METROPOLITAN AREA PLANNING
DEPARTMENT

Re: Administrative Adjustment 98-13: Administrative Adjustment to reduce the compatibility setback from 25 feet to 24 feet on the north side of the property.

Legal Description: Lot 14, 15, 16 and 17 Shreck's Addition.

A.1
of
Four

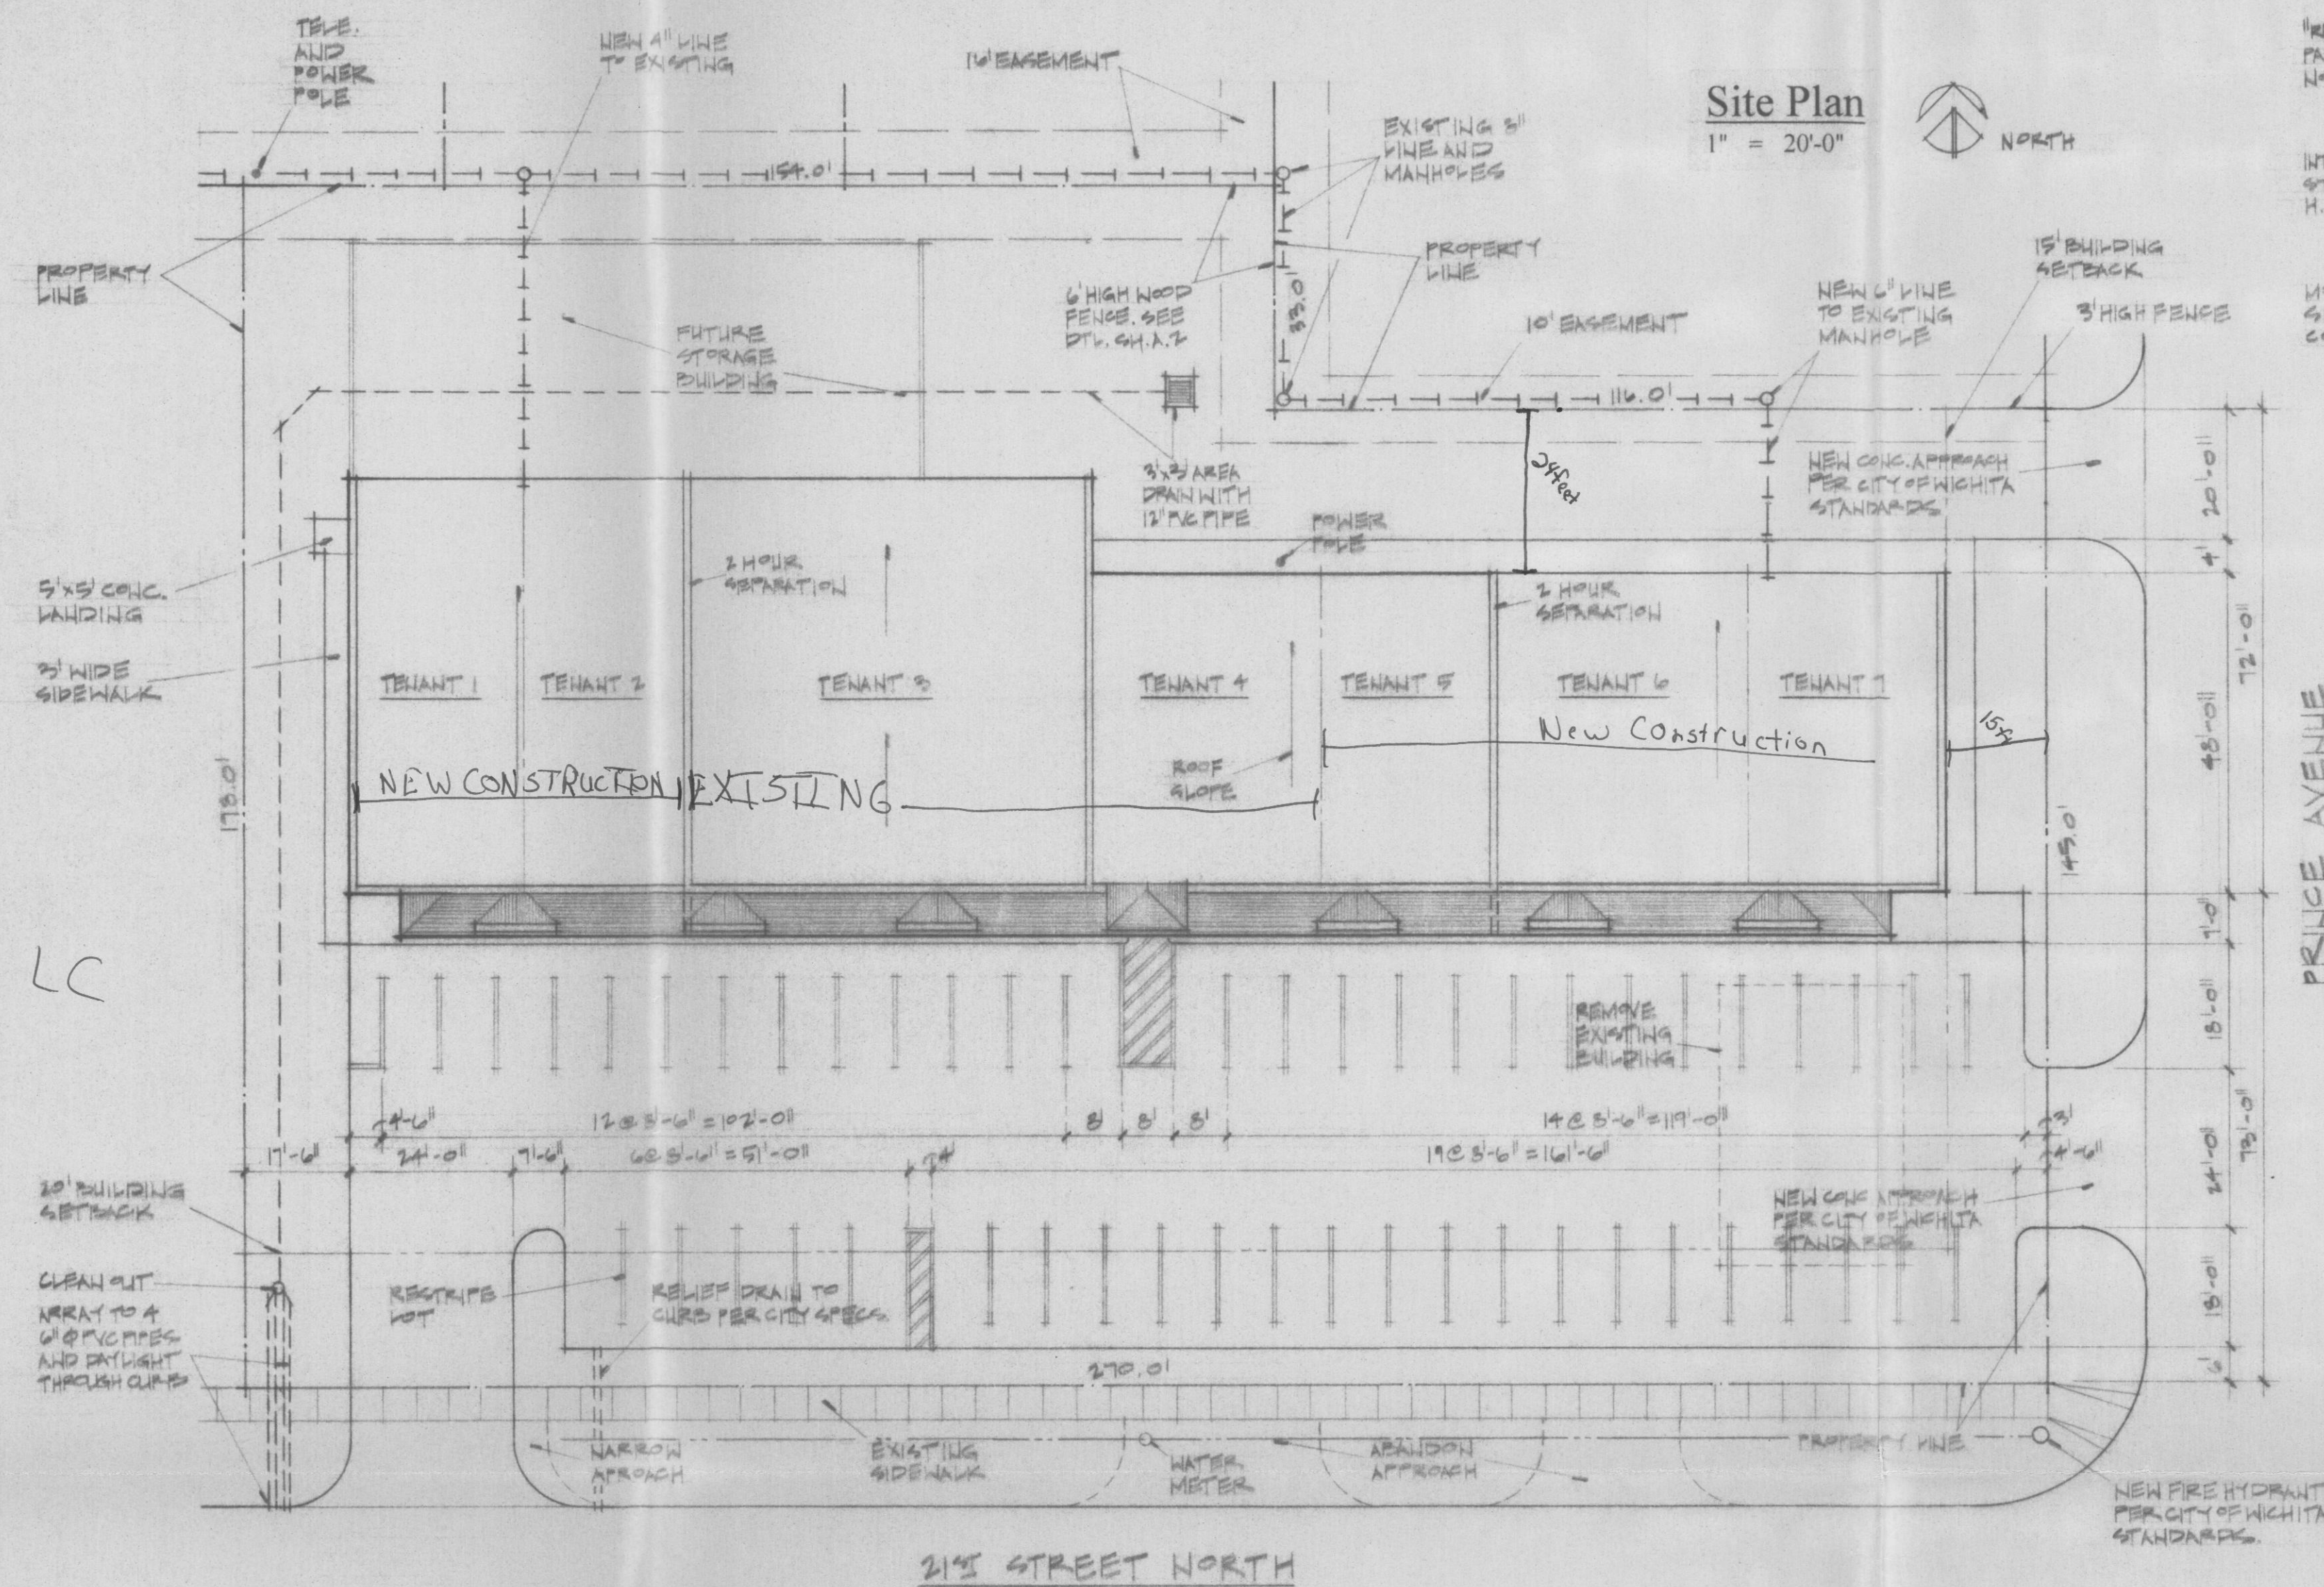
We have reviewed your request of an administrative adjustment to reduce the compatibility setback from 25 feet to 24 feet on the north side of the property. You have stated you would like to expand your existing building to the east and west. Due to your property being zoned "LC" Limited Commercial and the property to the north being zoned "SF-6" Single-Family you are required to maintain a 25 foot compatibility setback from the residentially zoned property. The compatibility setback will be met on the west side of the property but not on the east portion of this property.

As part of the this new construction you will also be required to meet the requirements of the Landscape Ordinance unless you are able to prove that you are unable to do so. The driveway along the north property line is only required to be 20 feet in width based on fire department requirements, therefore there is a four foot wide strip which could be used to meet the Landscape Ordinance requirements. The Landscape Ordinance requires eight trees to be planted along this north property line.

- 1) The applicant shall submit a revised landscape plan which meets the buffering requirement along the north property line. (A minimum of 8 trees)
- 2) The adjustment is only to reduce the compatibility setback from 25 feet to 24 feet for the buildings on the east portion of the property as shown on the attached site plan. This property should be developed in accordance with the site plan approved as part of this adjustment.
